Date: April 18, 1985

Our File: 0317588

Re: Review of Well Test Data - Well No. 3,
Sointula Waterworks District

SCALE: VERT. <u>AS SHOWN</u>	DATE <u>APRIL / 85</u>
HOR. <u>AS SHOWN</u>	
<u>M. WEI</u>	ENGINEER
FILE No. <u>0317588</u>	DWG No. <u>FIGURE 1</u>

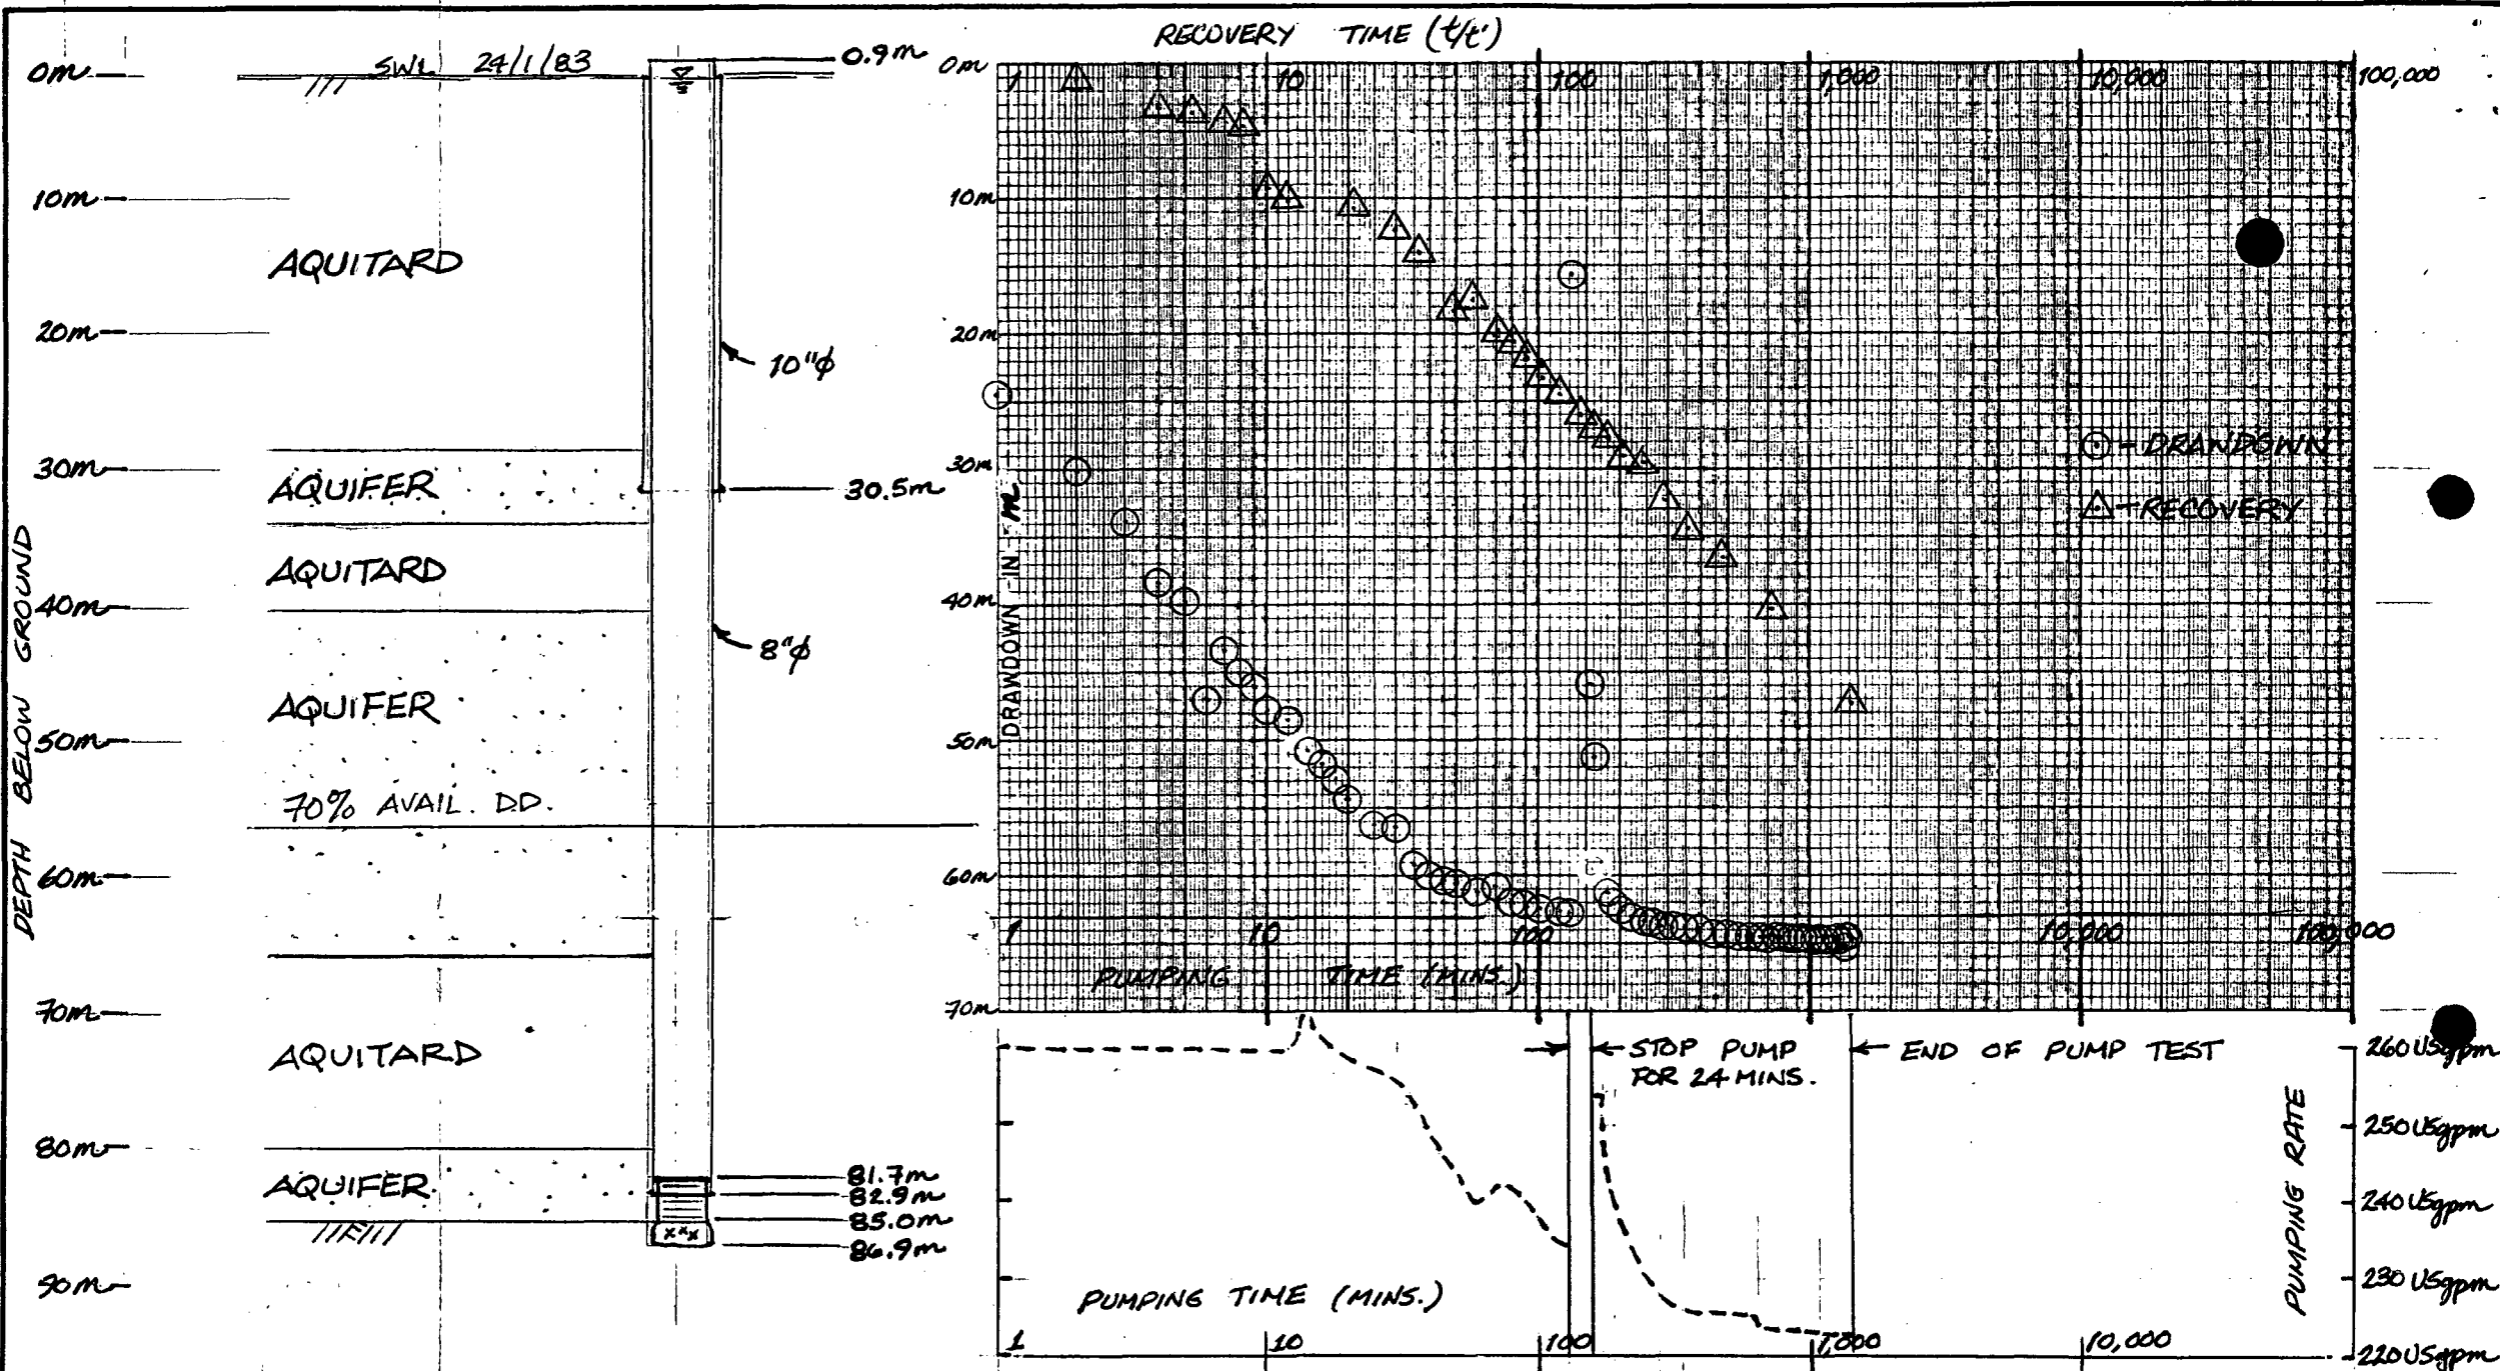
(with drive shoe). The bottommost aquifer was developed by setting a 3 m (10-foot) 150-slot 203 mm (8-inch) nominal size Johnson stainless steel screen bottoming at 85.0 m (279'). The screen assembly included a bottom plate and K packer and totalled 3.4 m (11 feet) in length. The 203 mm (8-inch) casing was pulled back to 82.9 m (272') to expose 2.1 m (7') of screen and the well was developed by air. The optimum transmitting capacity of the exposed screen based on Johnson (1975) is 22.1 L/s (350 USgpm). The water level was about 0.6 m (2') below ground level. Well details are summarized in Figure 1.

It is unknown if the annular space between the surface casing and well casing has been grouted or backfilled to form a sanitary seal around the well.

- 5) the annular space between the surface casing and well casing should be properly grouted or backfilled (if it hasn't already been done) to provide a surface sanitary seal around the well,

- 6) a recommended level for the pump setting is from 79.2 m (260') to 81.4 m (267'),
- 7) the well should be equipped with a suitable water meter to measure the total amount of water pumped from the well,
